MODEL
2016MY Sorento (UMa)
DATE
April 2017

TECHNICAL SERVICE BULLETIN

SUBJECT: SERVICE ACTION: FRONT DOOR OUTSIDE

HANDLE REPLACEMENT (SA283)

Left & Right Front Door Handles

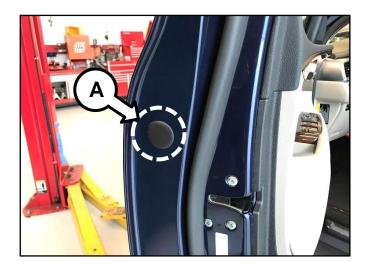
This bulletin provides the procedure to replace the left and right front outside door handle assemblies on some 2016MY Sorento (UMa) vehicles, produced from November 17, 2014 to January 25, 2016, which may experience a high effort / sticking feeling to open the front doors. Follow the procedure outlined in this bulletin to replace both front outside door handle assemblies. Before conducting the procedure, verify that the vehicle is included in the list of affected VINs.

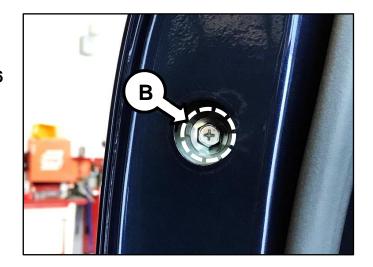
1. Using a non-marring trim removal tool, remove the door handle mounting bolt cover (A).

Loosen the mounting bolt (B).

Tightening torques: 34.8 – 51.6 lb.in (3.4 – 5.7 Nm, 0.4 – 0.6 kgf.m)

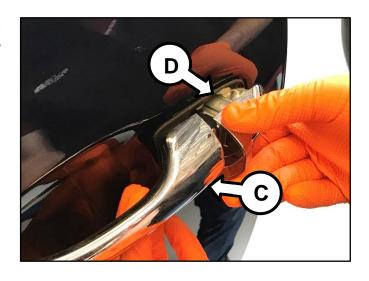
3. Slightly pull the door outside handle (C) and remove the door outside handle cap (D).
